**Re: Appeal of Planning Commission to deny proposed improvements
Kum & Go, #413
CEI Project No. 26728.0**

Subject: LSD 11-3966 (Kum and Go at Martin Luther King and Hill Avenue)

TO: Fayetteville Planning Commission
 FROM: Andrew Garner, Senior Planner
 Glenn Newman, Staff Engineer
 THRU: Jeremy Pate, Development Services Director
 DATE: ~~November 1, 2011~~ *Updated November 15, 2011*

LSD 11-3966: Large Scale Development (SOUTHWEST CORNER MLK BLVD. & HILL AVE./KUM AND GO, 522): Submitted by CEI, INC. for property located at the SOUTHWEST CORNER OF MARTIN LUTHER KING BOULEVARD AND HILL AVENUE. The property is zoned C-1, NEIGHBORHOOD COMMERCIAL and contains approximately 2.46 acres. The request is for the development of a gas station with sixteen fuel pumps.

**APPEAL
PROPOSED ACCESS**

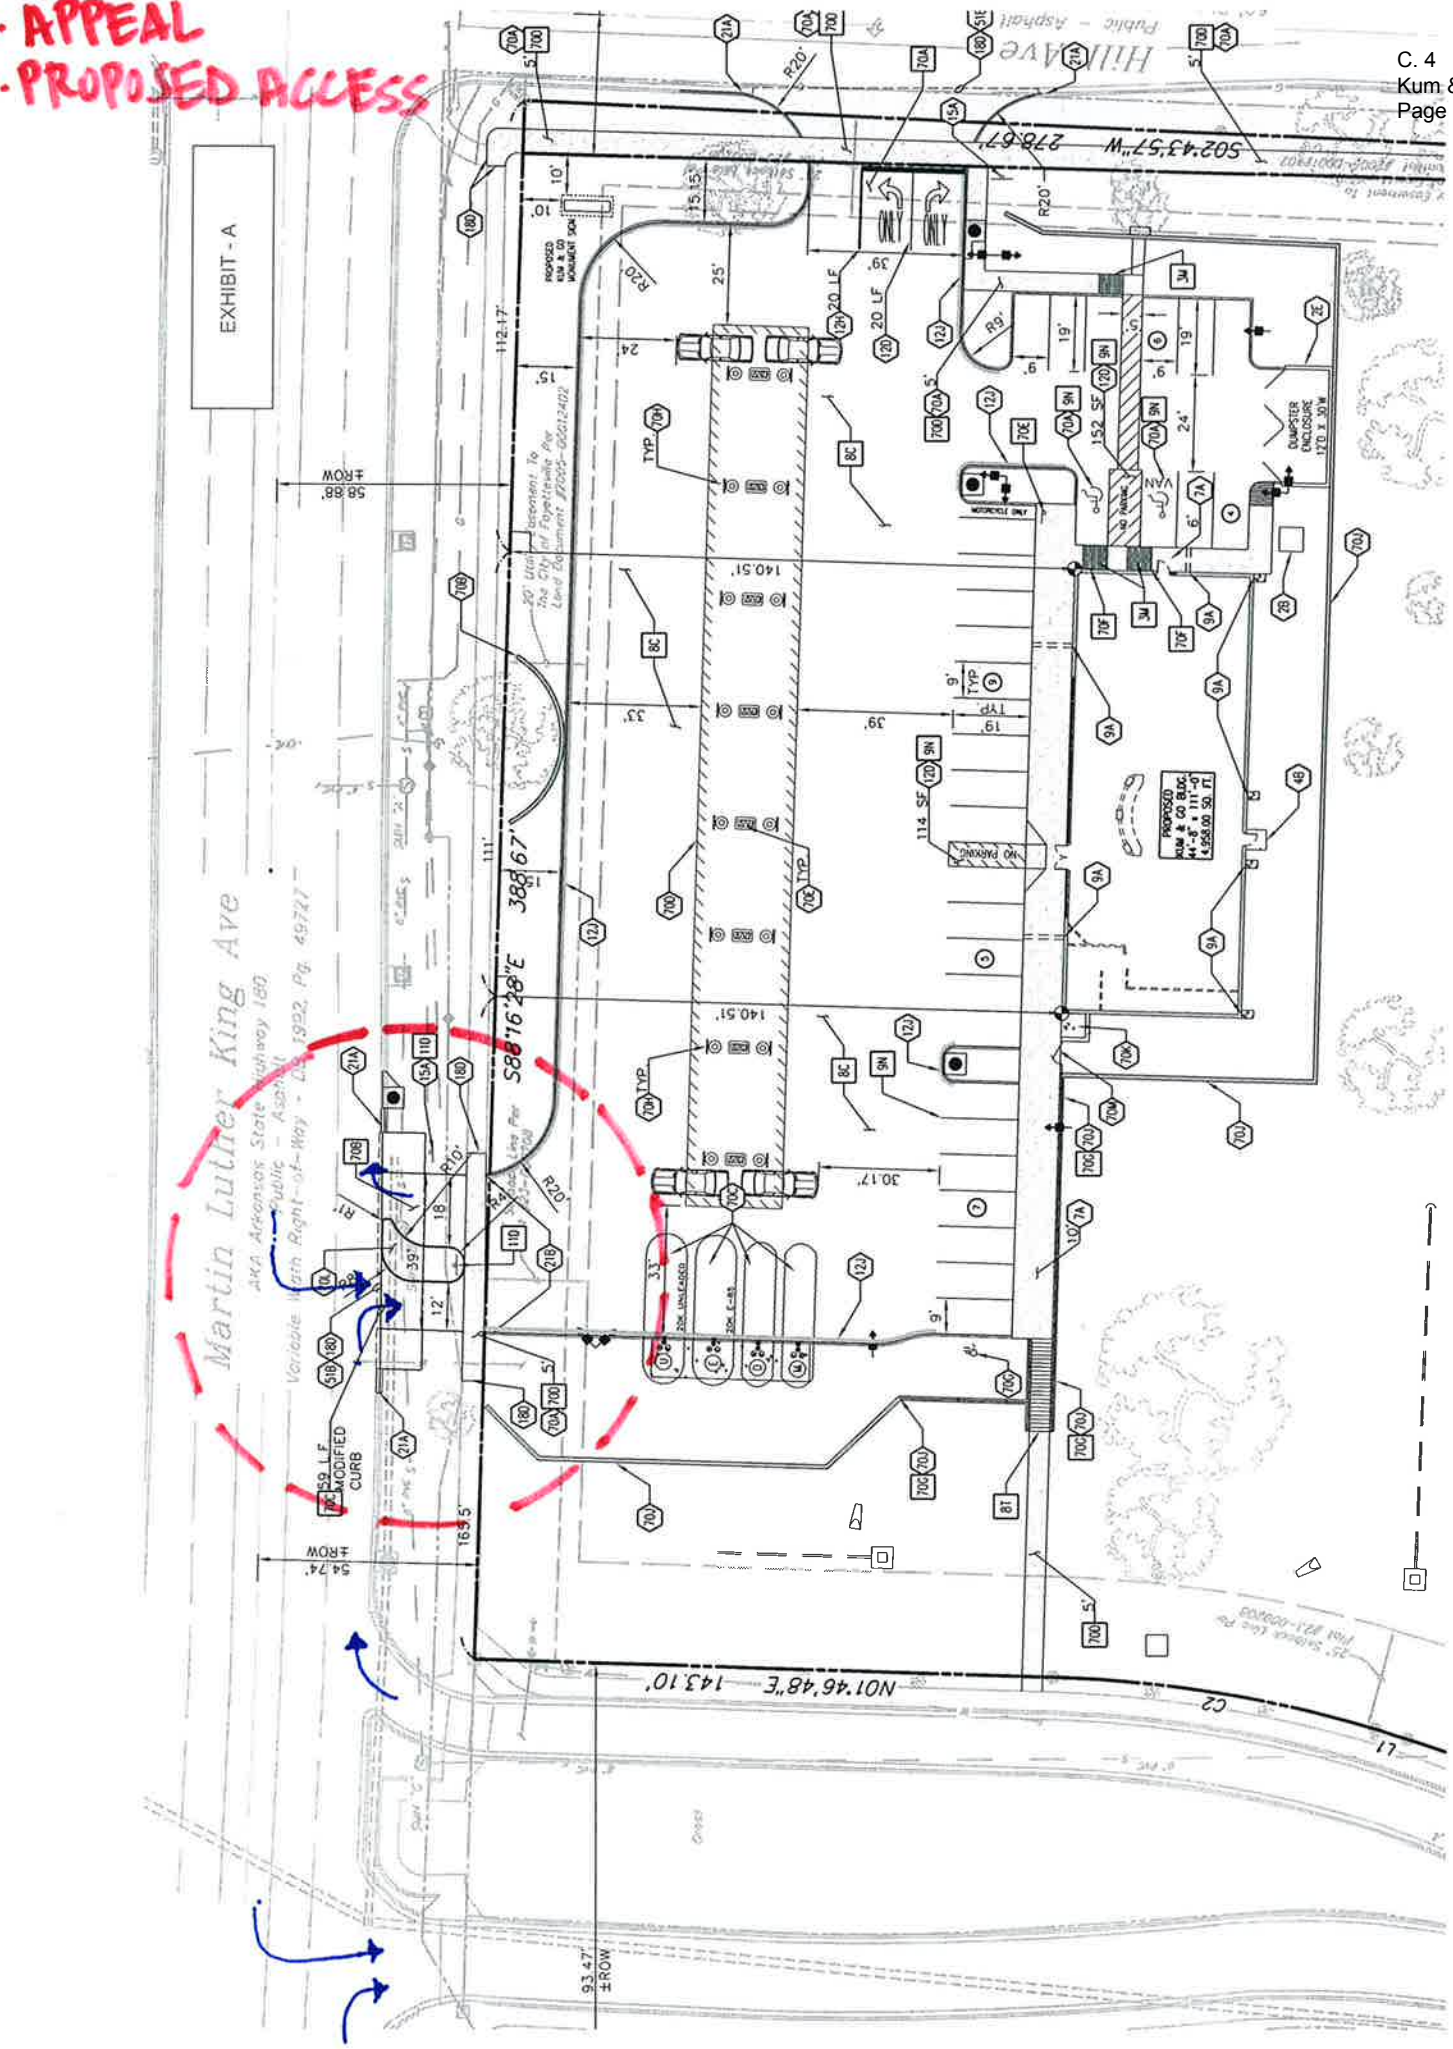
Following the Planning Commission meeting dated November 14, 2011, Kum and Go has made the following revisions to the site plan (See Exhibit – A).

- The MLK Jr. Blvd. access drive has been shifted to the west approximately 30'. This shift is to address the traffic stacking in the left turn lane along MLK Jr. Blvd. and for those vehicles wanting to proceed north onto Hill Ave.
- A pedestrian sidewalk connection has been included to extend from Royal Oak to the proposed convenience store.

Curb Cut Distances

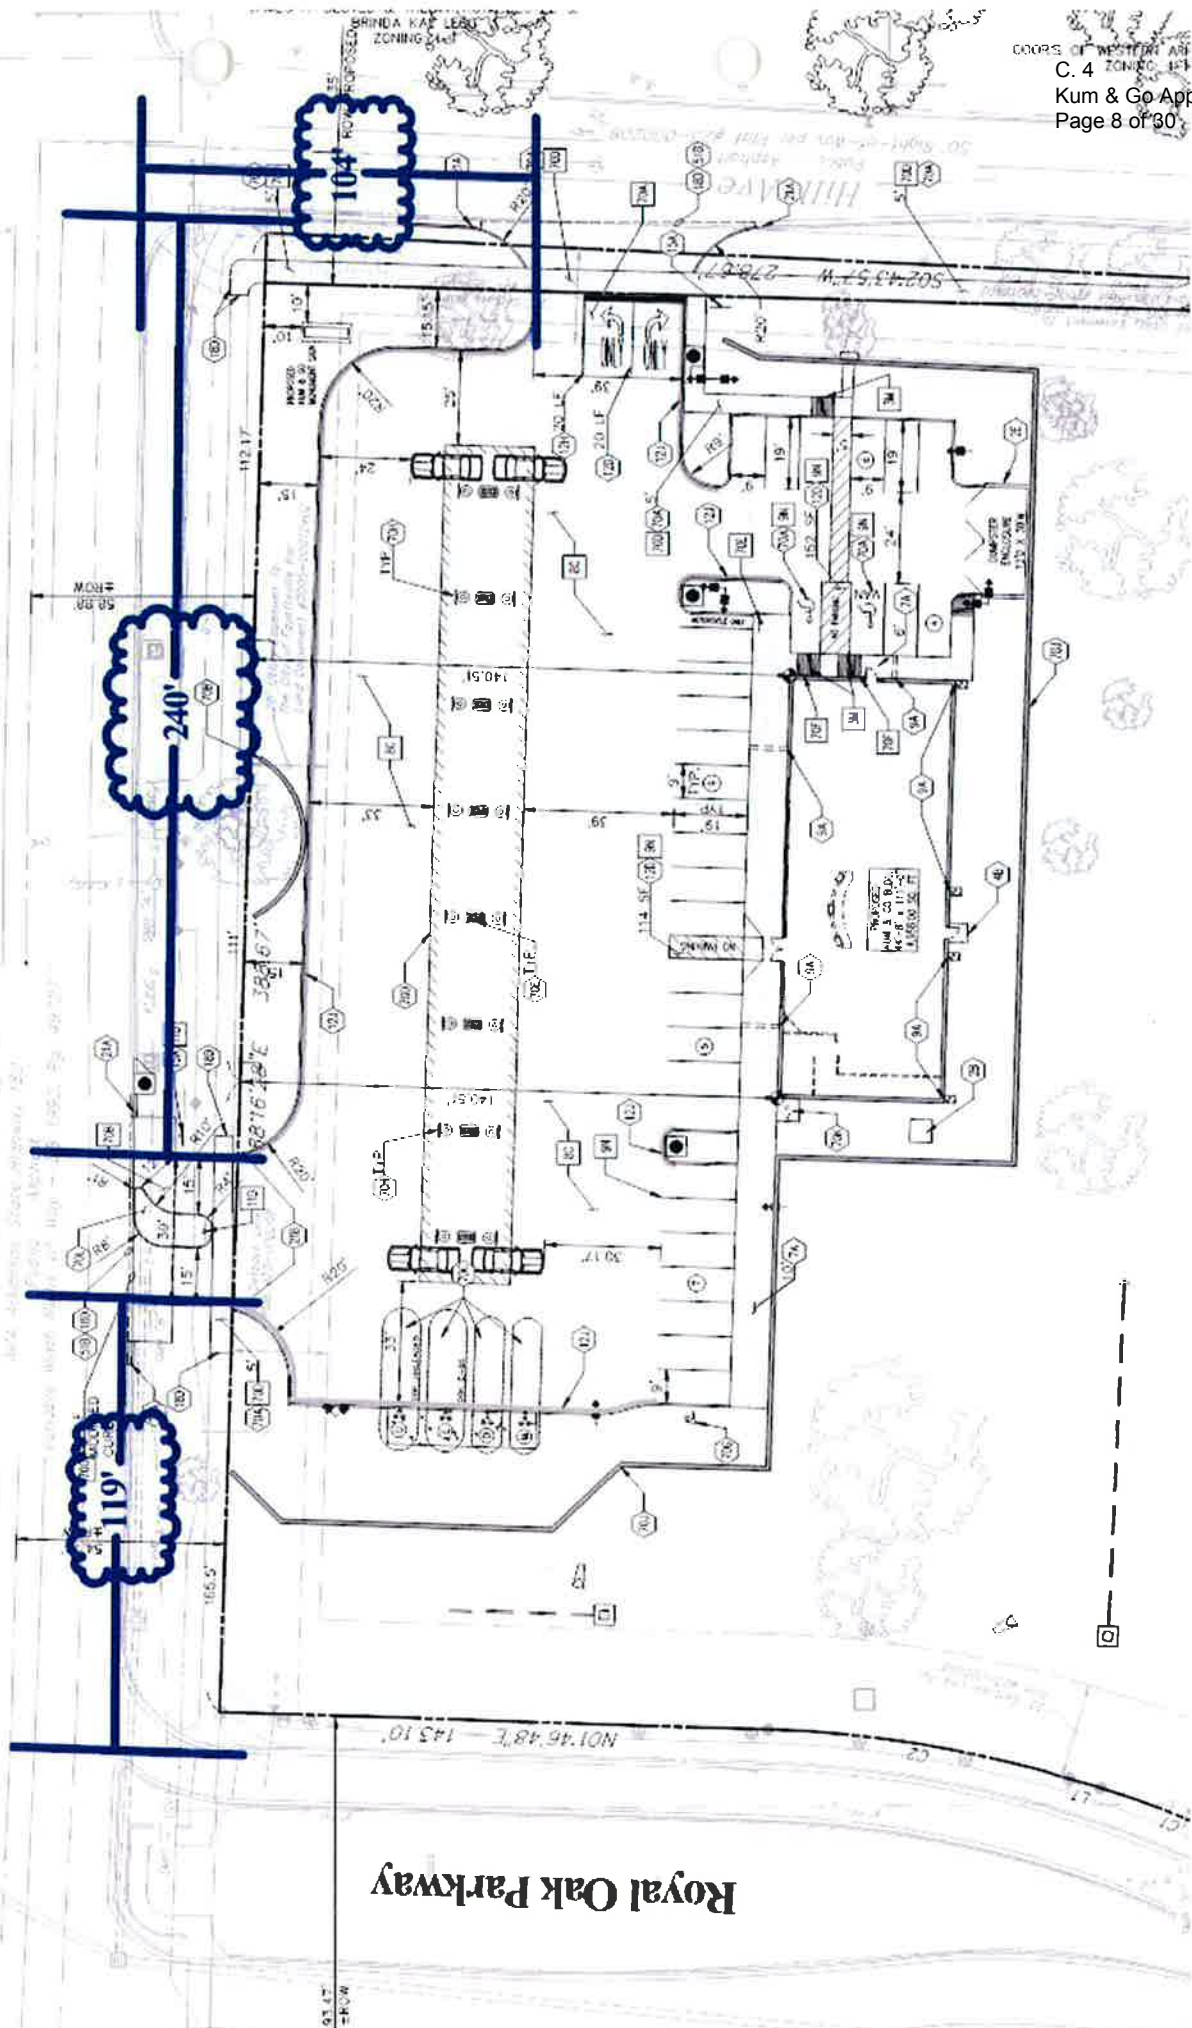
Area of vehicular conflict

approximately 150' transition left turn into gas station

100' break in turn lane for left turn on Hill

**Site Distance Photo:
View from Royal Oak Parkway looking west on Martin Luther King Boulevard**

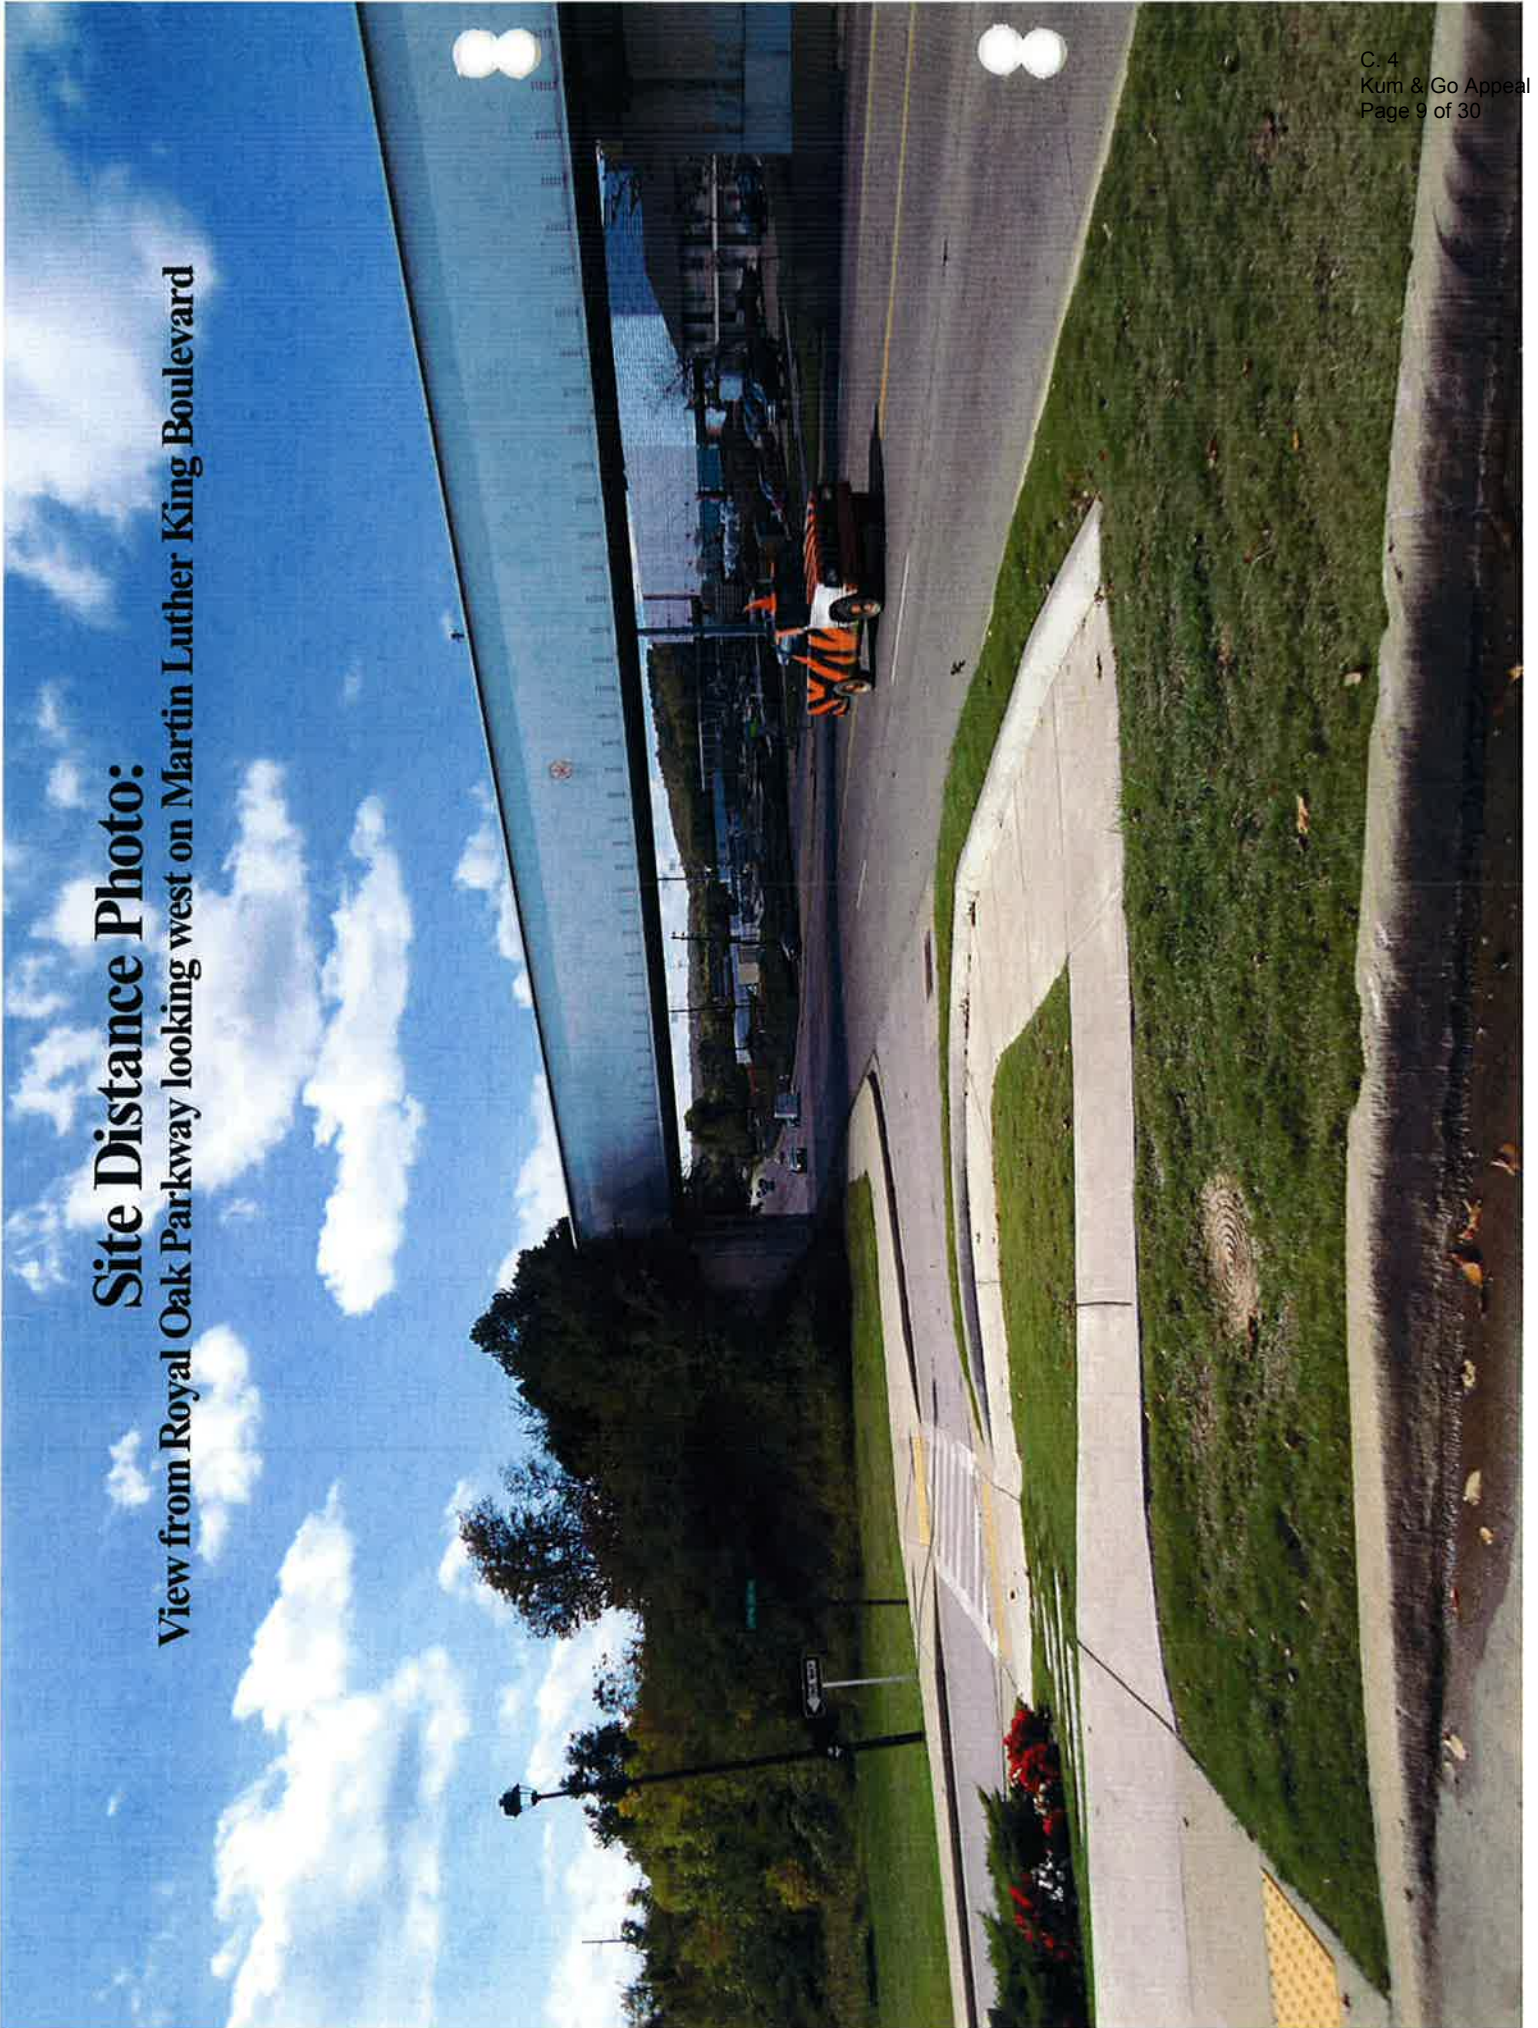
Staff has conducted several site visits to observe traffic flow, site distance, and turning movements in the area. The site has adequate access on two adjacent side streets, including a signalized intersection at Hill Avenue. The proposed full access in and right-out only curb cut on Martin Luther King (MLK) may create a traffic safety hazard due to conflicting turning movements, especially with vehicles turning left into the development conflicting with vehicles turning right out of Royal Oak Parkway, and vehicles traveling at relatively high speed east and west on MLK. There is also a potential danger with westbound vehicles entering the turn lane on MLK to turn left into this development, and eastbound vehicles on MLK entering the turn lane to turn left at the signal on Hill Avenue and potential head-on conflict within the stacking of the intersection. This is depicted on a video clip shown at agenda session and planning commission and indicated on a diagram provided by staff. As observed by staff, vehicles stack in the left eastbound lane on MLK because the right lane is required to turn right at the next intersection. This stacking encourages vehicles to travel down the center turn lane of MLK which will be in direct conflict with vehicles heading westbound and turning left into the gas station.
